DOC: IEEE P802.11-95/84

Title: **Remarks on 802.11-95/76 (section 10 of 802.11D1.1)**

Author: Naftali Chayat

Figure 10-4: Frame Synchronous Scrambler/Descrambler.

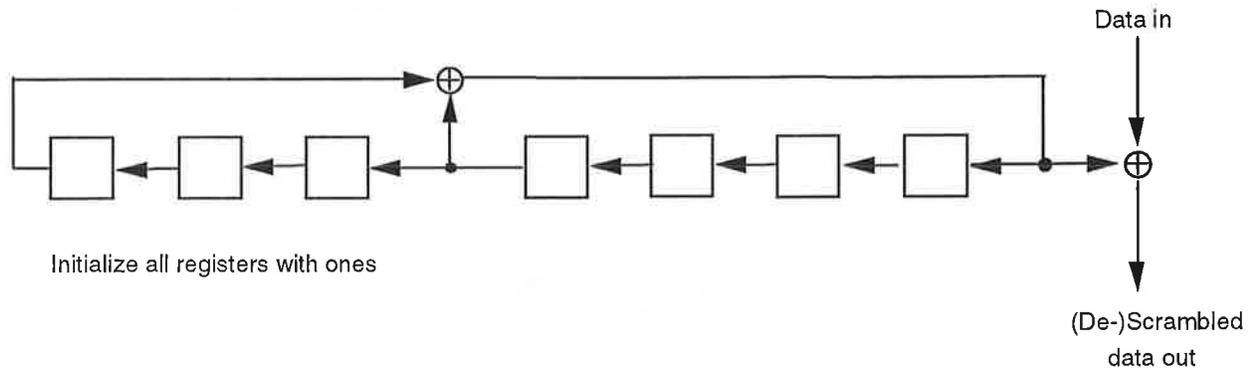
1. Inconsistency in scrambler description vs. figure remained in D1.1

The inconsistency, as pointed out in remark by A. Bolea, remained. To my opinion, the figure should be updated, and the sequence fully listed in the text, as in a draft document I passed to Dean K. (text enclosed):

The PLCP_PDU data whitener uses a length-127 frame synchronous scrambling followed by a 32/33 Bias Suppression Encoding to randomize the data from highly redundant patterns and to minimize the data DC bias and maximum run lengths. Data bytes are placed in the transmit serial bit stream LSB first and MSB last. The frame synchronous scrambler uses the generator polynomial $S(x)$ as follows:

$$S(x) = x^7 + x^4 + 1$$

and is illustrated in Figure 10-4. The 127-bit sequence generated repeatedly by the scrambler is (leftmost used first) 00001110 11110010 11001001 00000010 00100110 00101110 10110110 00001100 11010100 11100111 10110100 00101010 11111010 01010001 10111000 11111111. The same scrambler is used to scramble transmit data and descramble receive data. The data whitening starts with the first bit of the PLCP_PDU which follows the last bit of the PLCP Header. The specific bias suppression encoding method used is defined in Figure 10-7a. The format of the packet after data whitening is as shown in Figure 10-5.
